RENESAS TECHNICAL UPDATE

Product Category	MPU/MCU		Document No.	TN-RX*-A0255A/E	Rev.	1.00
Title	Errata to the Electrical Characteristics Regarding the Voltage Reference of RX23E-A Group MCU		Information Category	Technical Notification		
Applicable Product	RX23E-A Group	Lot No.	Reference Document	RX23E-A Group User's Manual: Hardware Rev.1.10 (R01UH0801EJ0110)		
		All

We notify corrections to the initial accuracy and temperature drift of the voltage reference described in the RX23E-A Group User's Manual: Hardware, Rev.1.10.

Figure 39.98 Temperature Dependence of Output Voltage of Voltage Reference (AVCC0 = 5.0 V)

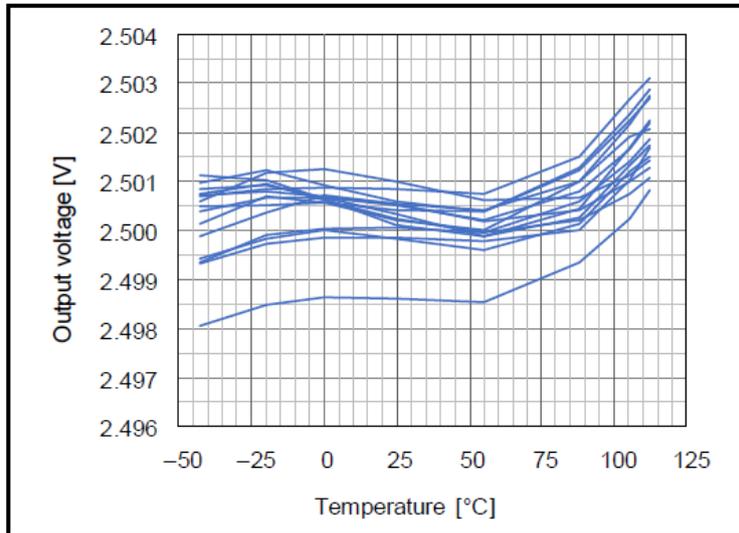
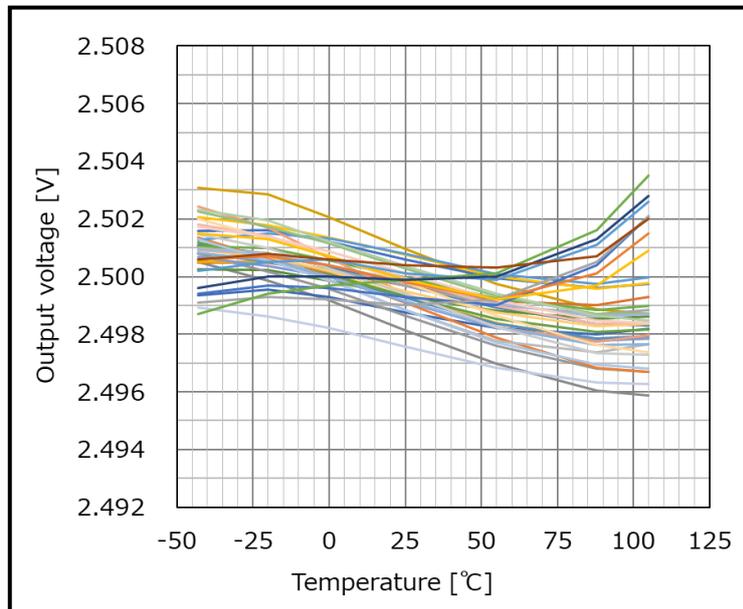
Figure 39.98, Temperature Dependence of Output Voltage of Voltage Reference is modified as follows.

Figure 39.99 Initial Accuracy of Voltage Reference (AVCC0 = 5.0 V)

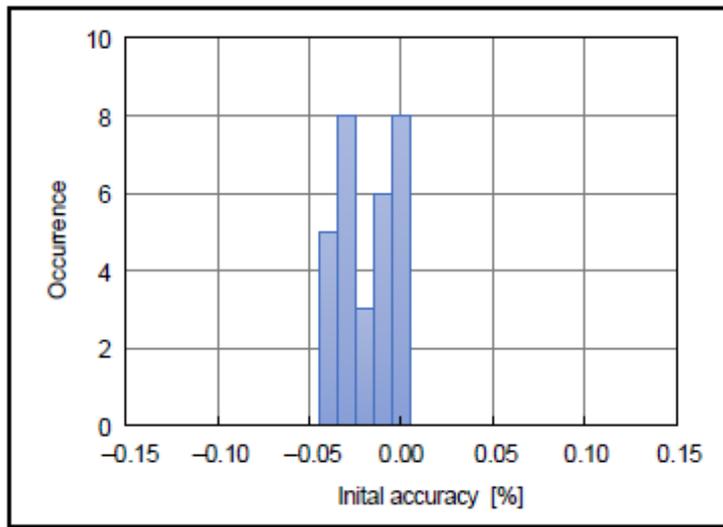
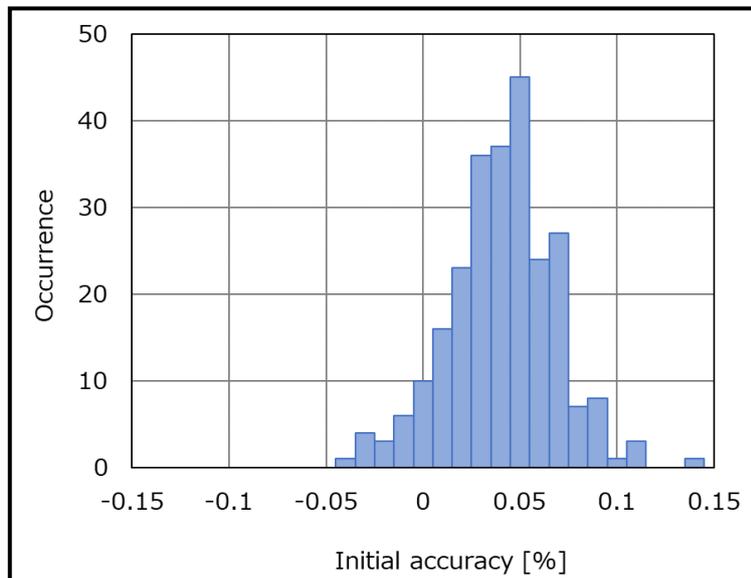
Figure 39.99, Initial Accuracy of Voltage Reference is modified as follows.
